AMENDMENTS 'A' - Feb 2023 - gradient of ramp from existing garage to new garage lessened to 11%	JO WILLMORE DESIGNS 11 Hudson Parade Clareville NSW 2107 (02) 9918 2479 ABN 27 370 370 173	ALTERATIONS AND ADDITIONS for: A. Warne & A. Hughes at: LOT 8, DP 1011074, 9 Maybanke Court MONA VALE, 2103	drawing title SITE PLAN	date: DECEMBER 2022 scale: 1:200 (A3)
			NOTE: Use figured dimension only. Do not scale off drawings . All levels and dimensions to be verified prior to construction of work	drawing number DA-01A

ALTERATIONS AND ADDITIONS

for: A. Warne & A. Hughes
at: LOT 8, DP 1011074, 9 Maybanke Court
MONA VALE, 2103

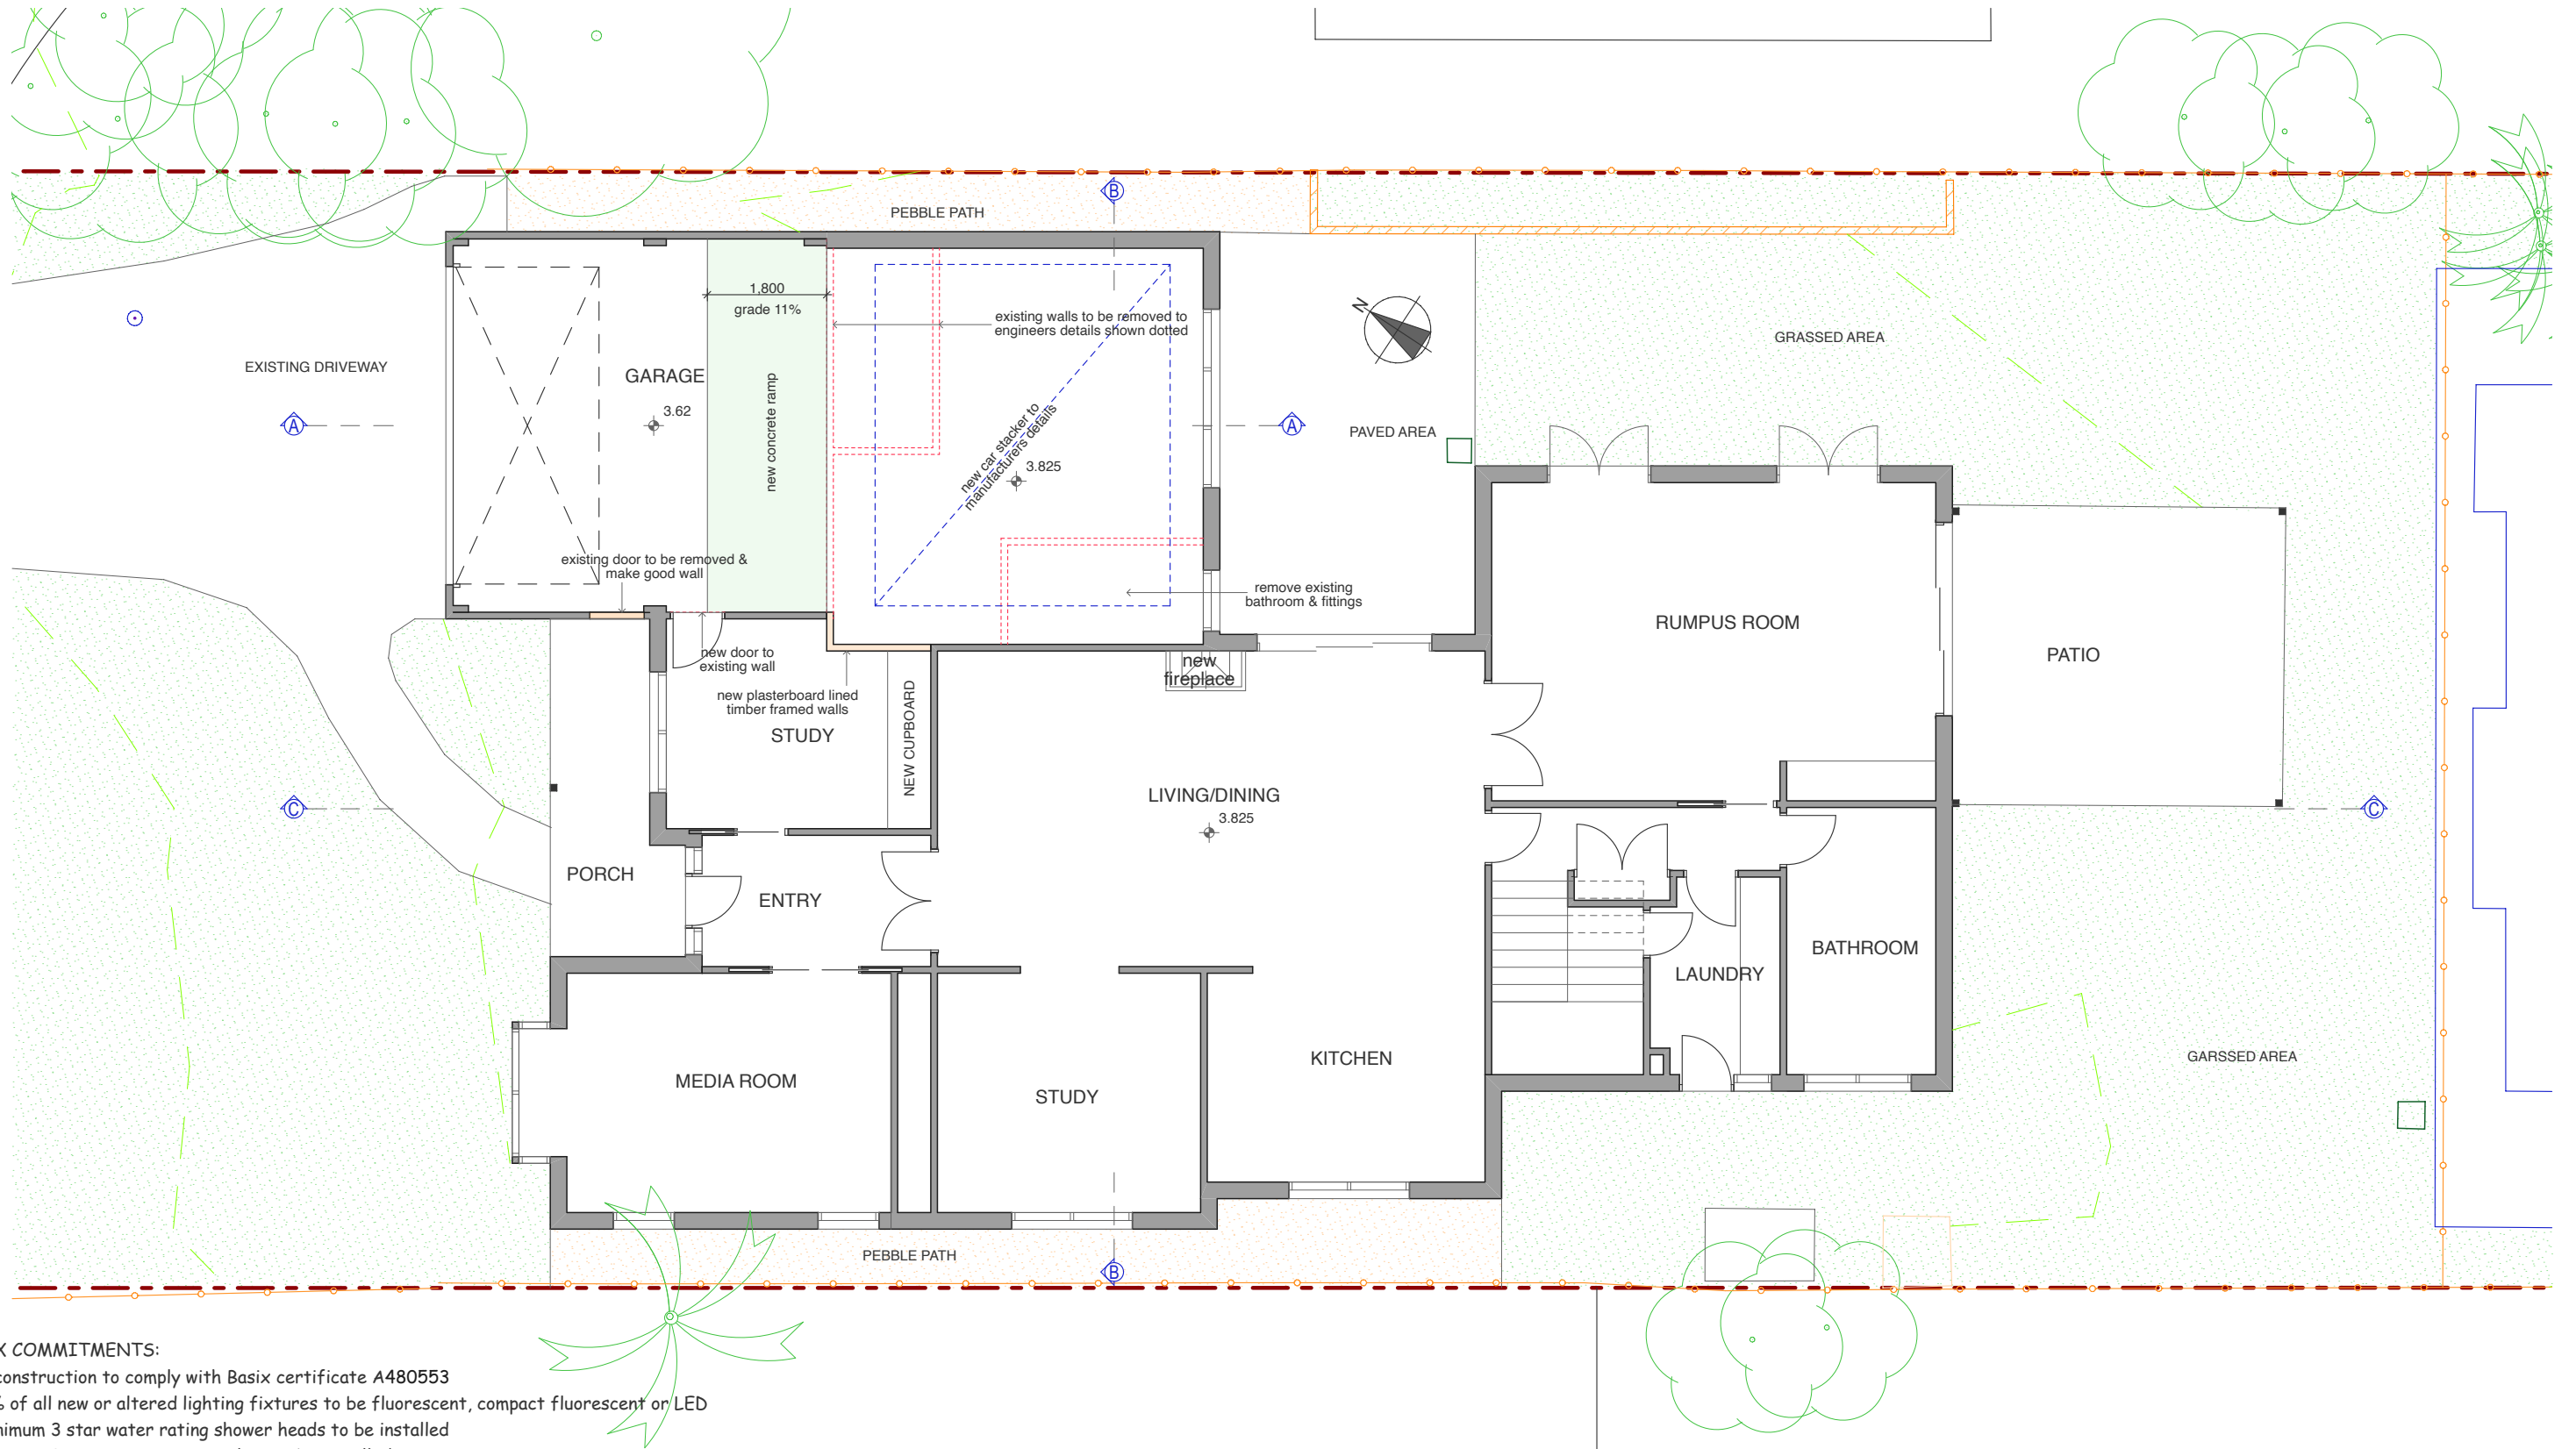
AMENDMENTS 'A' - Feb 2023 - gradient of ramp from existing garage to new garage lessened to 11%	JO WILLMORE DESIGNS 11 Hudson Parade Clareville NSW 2107 (02) 9918 2479 ABN 27 370 370 173	ALTERATIONS AND ADDITIONS for: A. Warne & A. Hughes at: LOT 8, DP 1011074, 9 Maybanke Court MONA VALE, 2103	drawing title GROUND FLOOR PLAN	date: DECEMBER 2022 scale: 1:100 (A3)
			NOTE: Use figured dimension only. Do not scale off drawings . All levels and dimensions to be verified prior to construction of work	drawing number DA-02A

SECTION CC

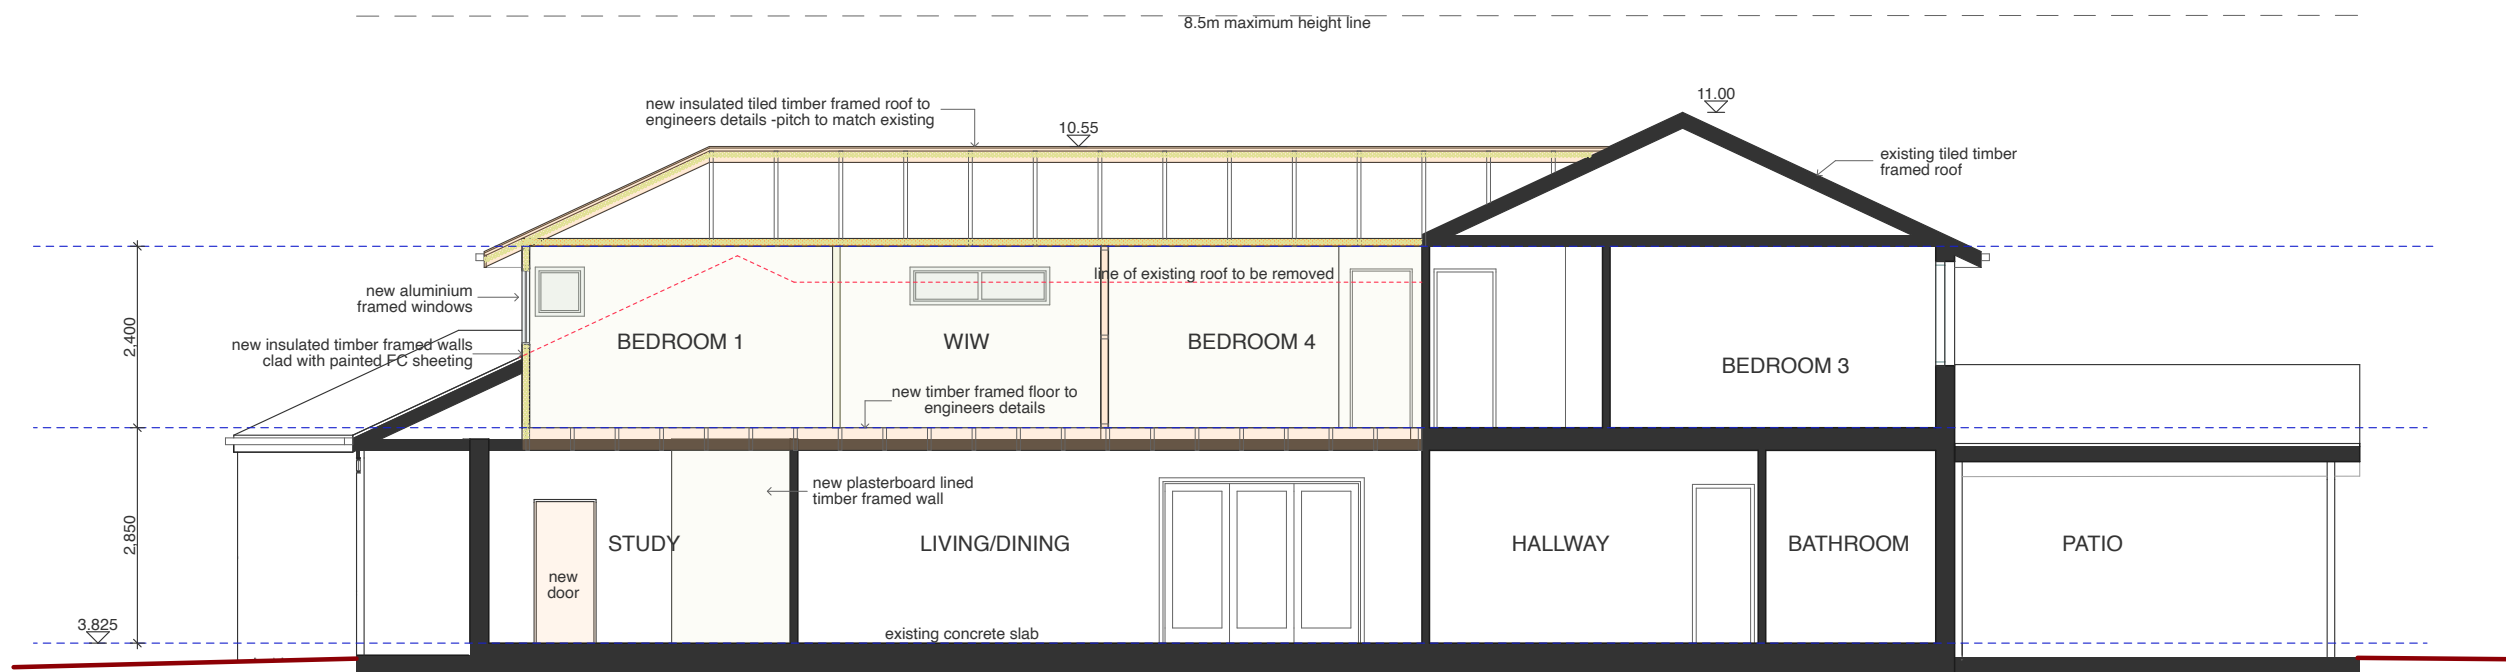
'A' - Feb 2023 - gradient of ramp from existing garage to new garage lessened to 11%
